Addendum # 1

Bid Opportunity: 25-7632-RFT - Crestview Public School Main Office Renovation and Ventilation Upgrade

ADDENDUM NO. 1

ADDENDUM 01

Item 01: Drawing A05 PARTIAL ROOF DEMOLITION & PROPOSED PLAN & DETAILS

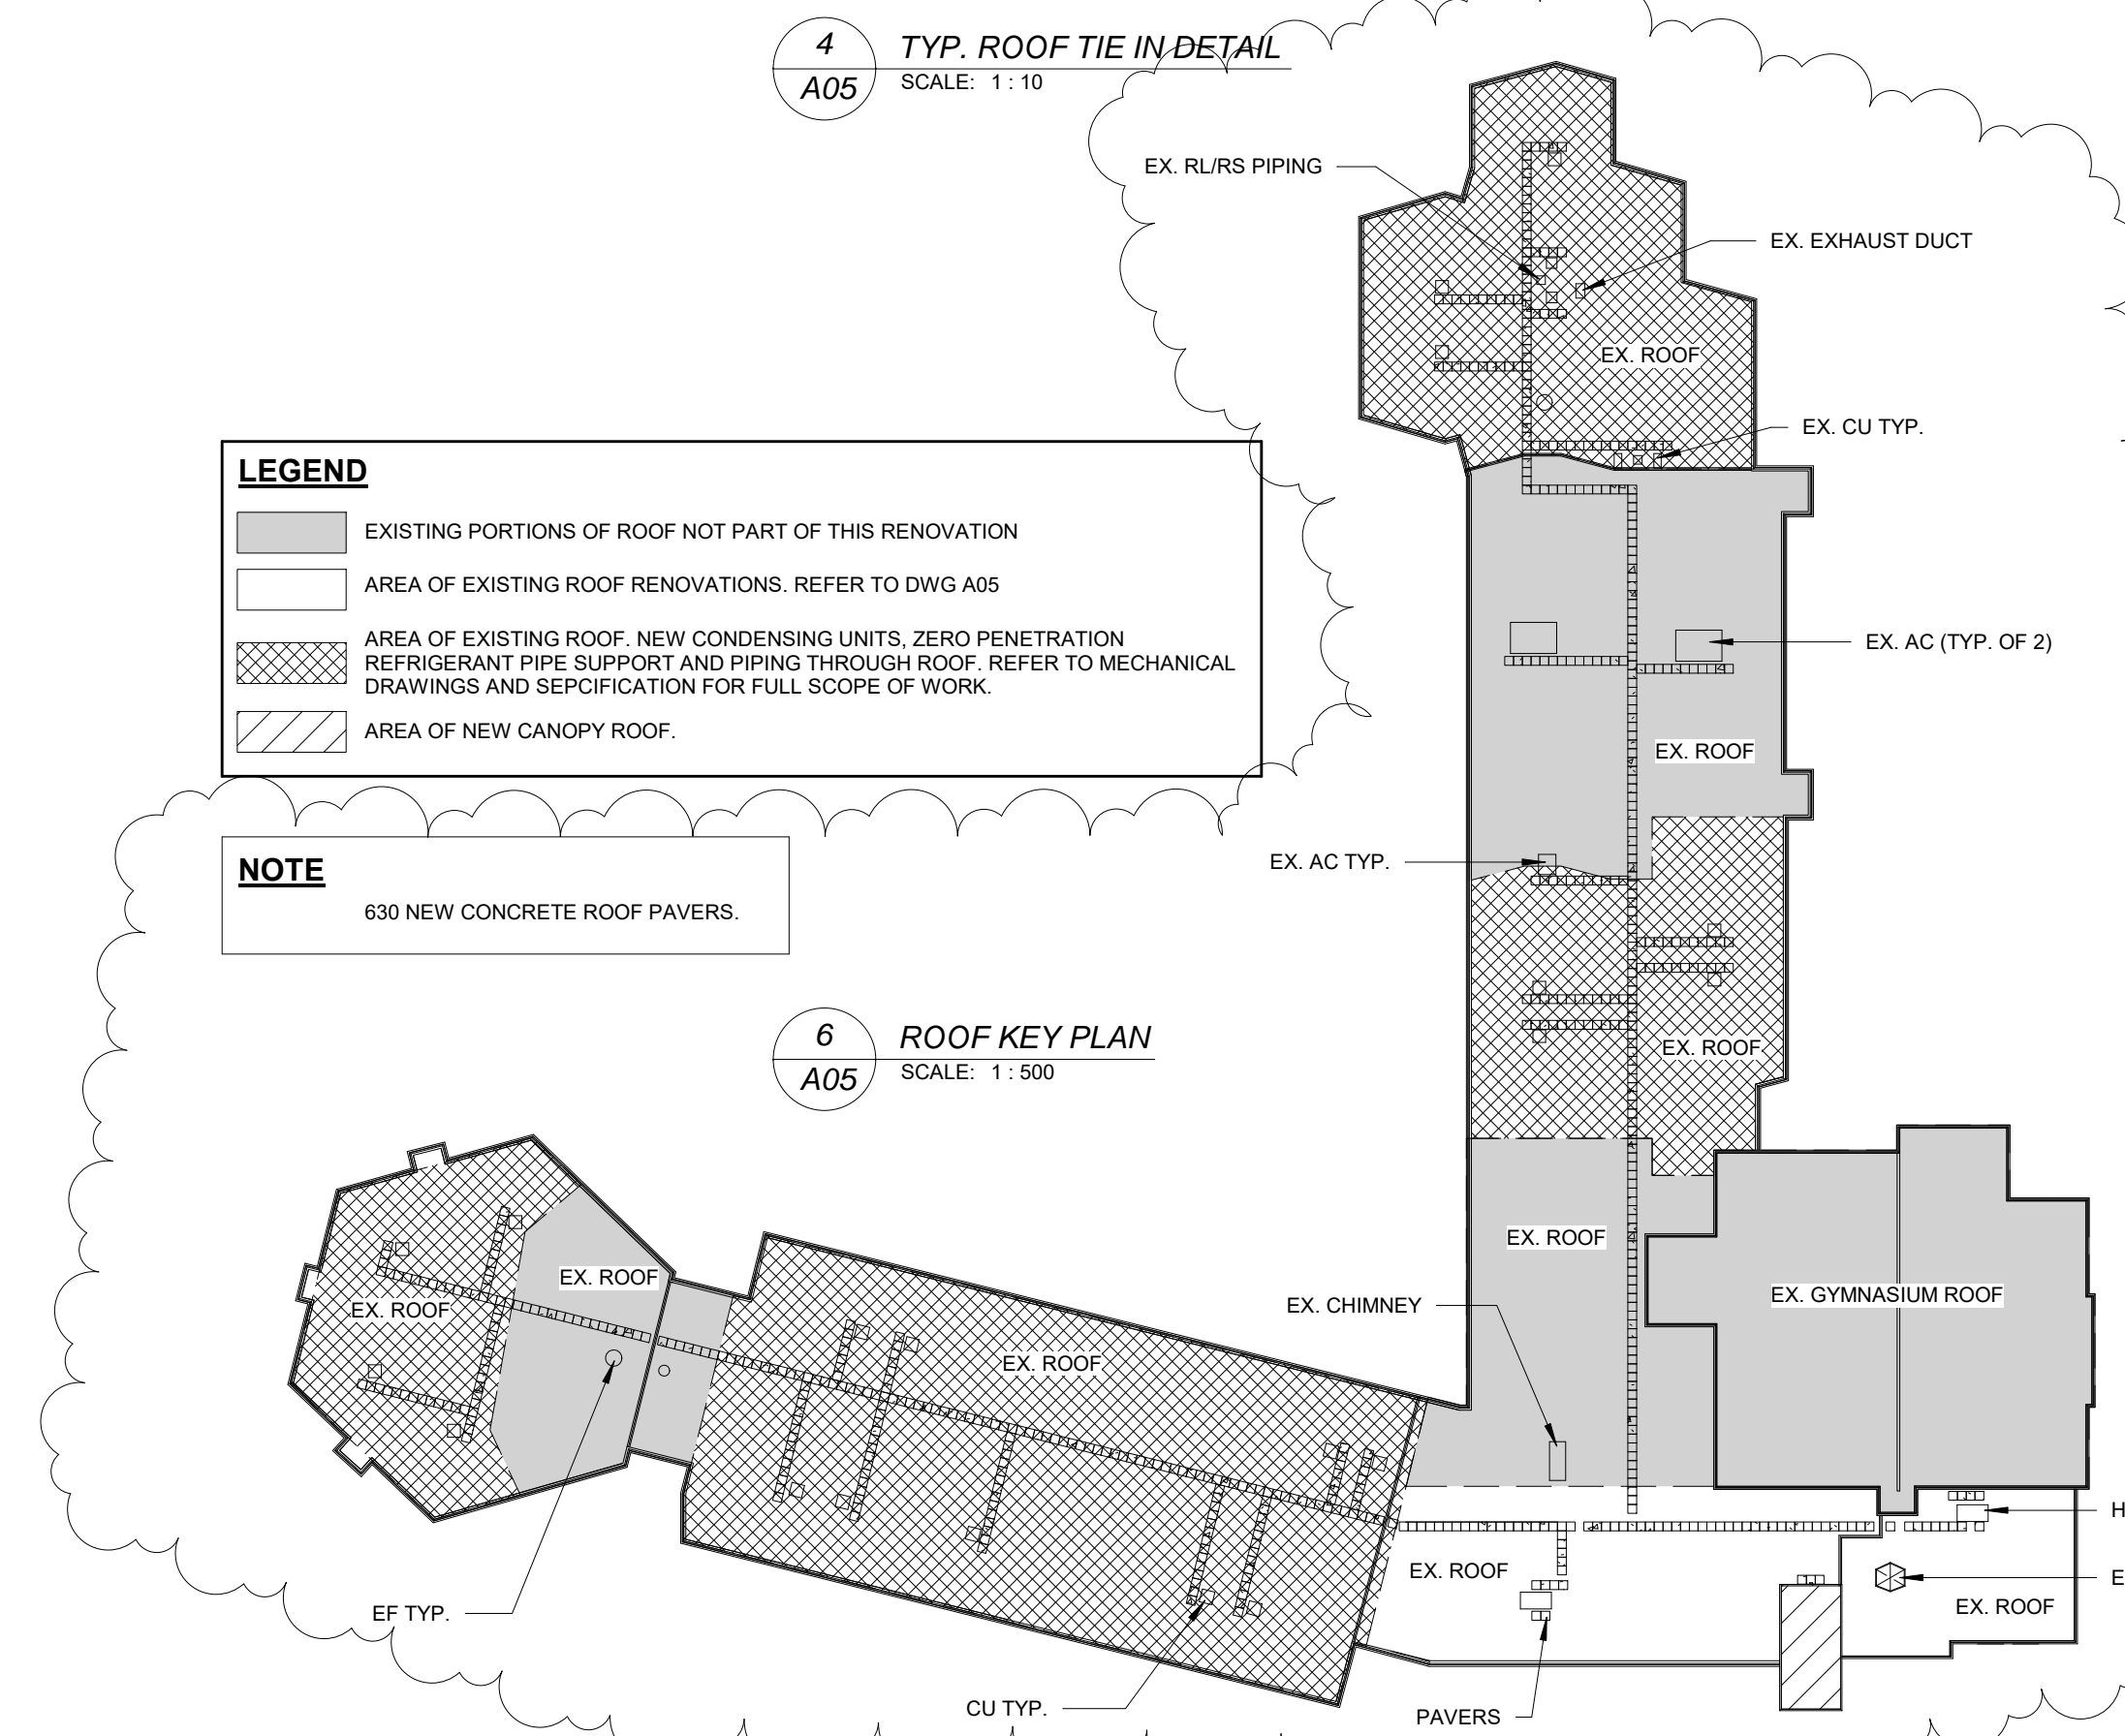
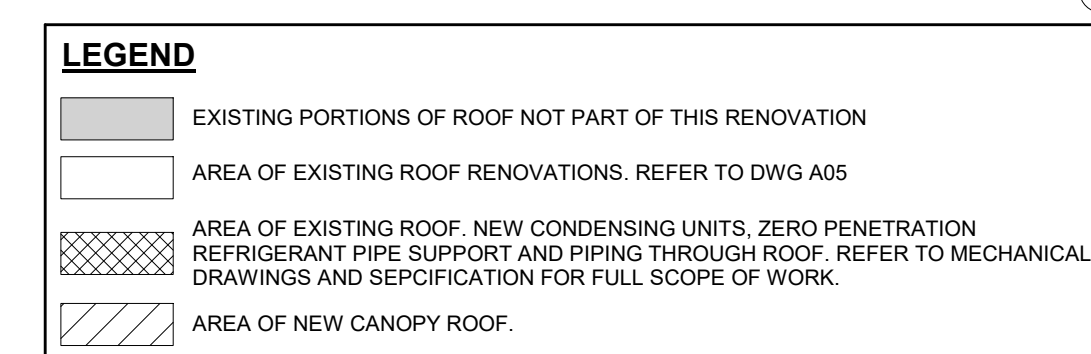
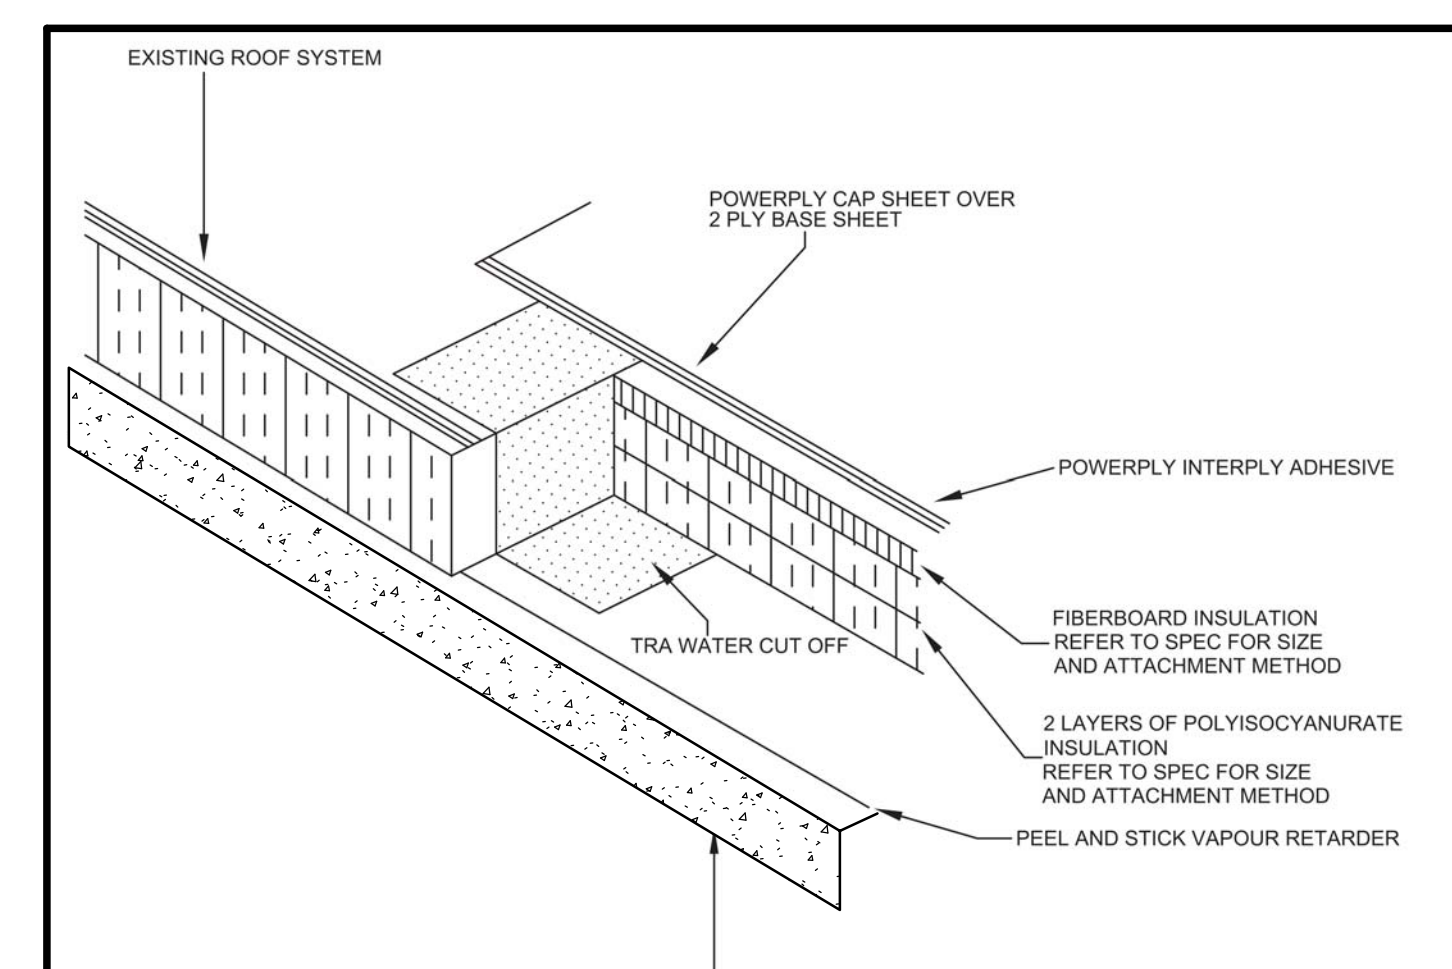
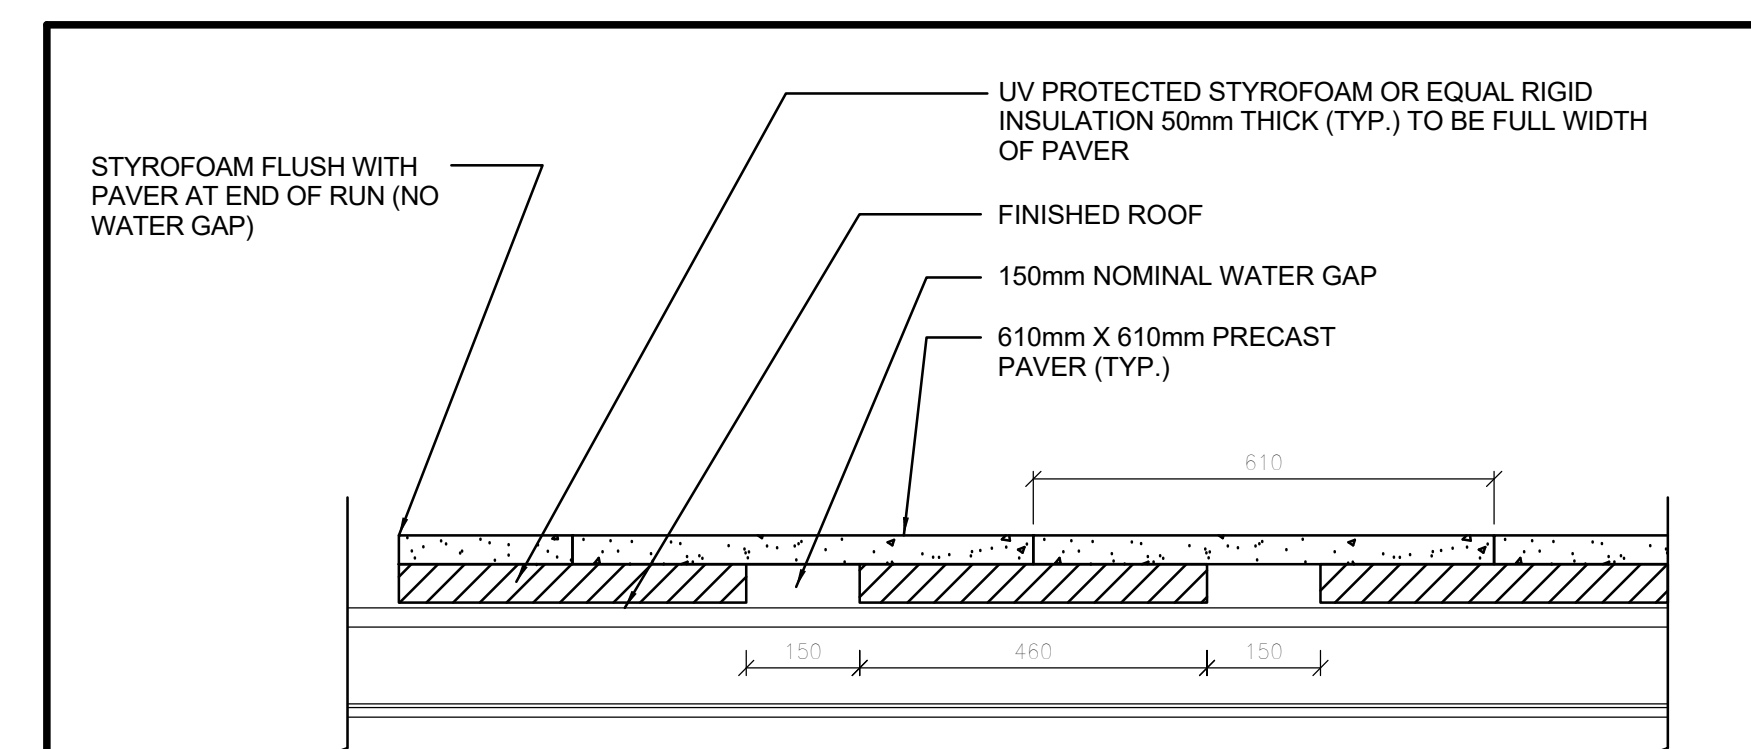
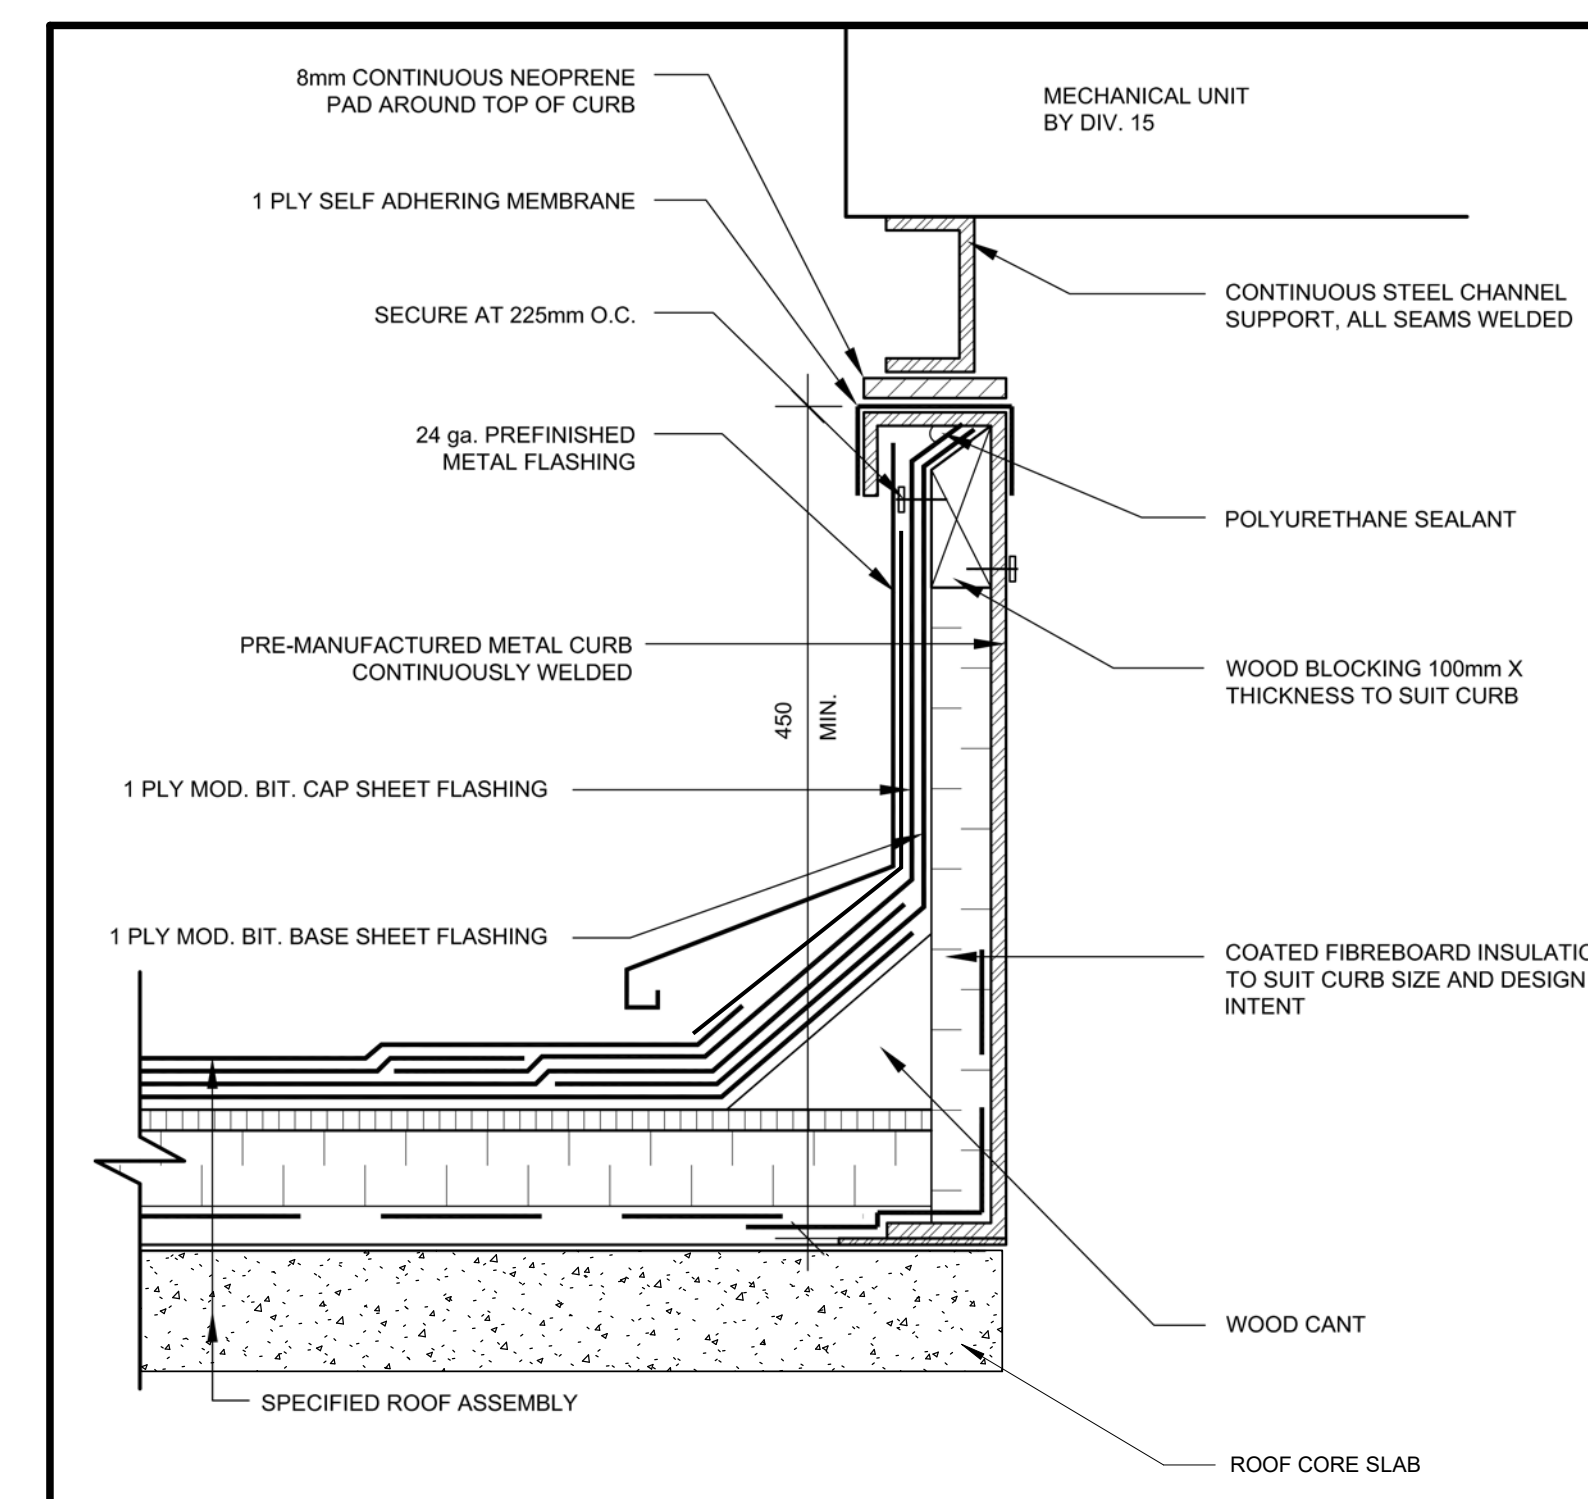
- .1 REPLACE Drawing A05 with the enclosed A05 Drawing.

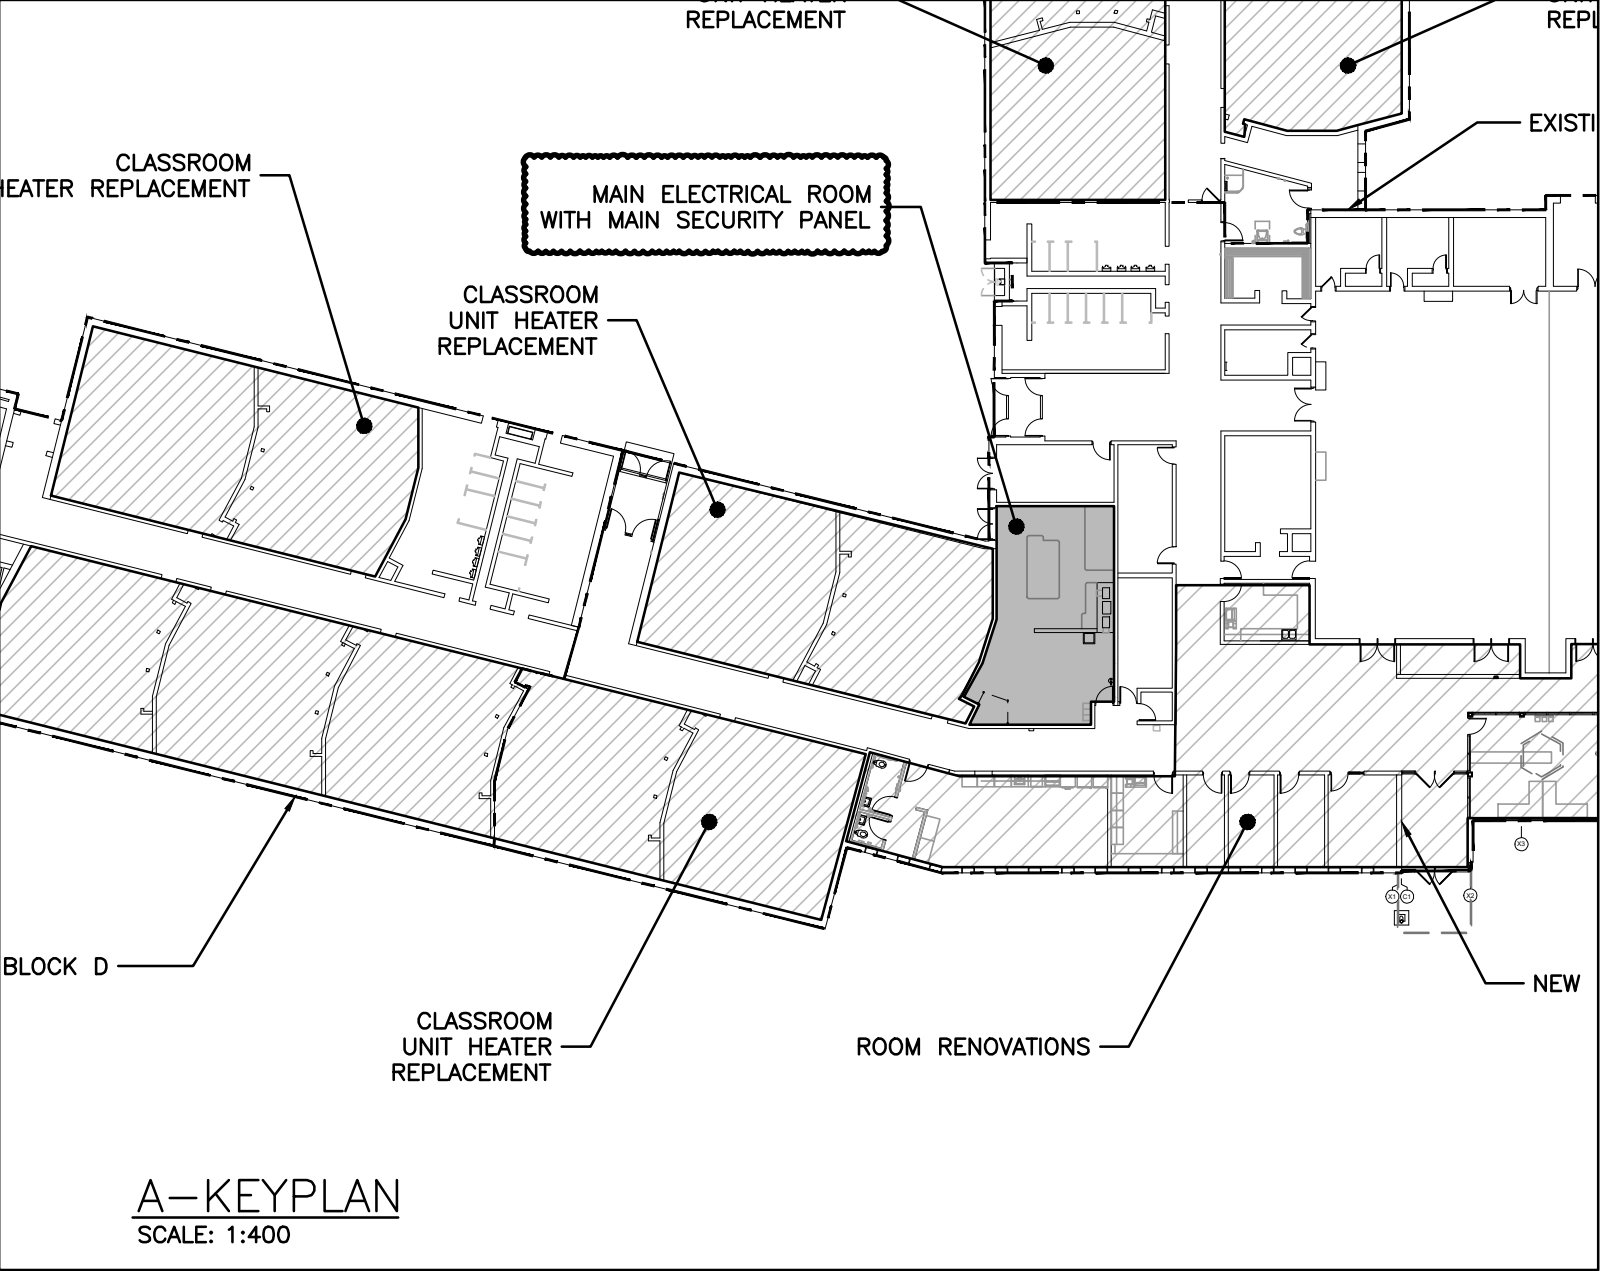
- .1 All data and voice drops are to be rough-in only.
- .2 Added ceiling mounted emergency battery unit to legend.
- .3 Added note to key plan indicating location of security panel.
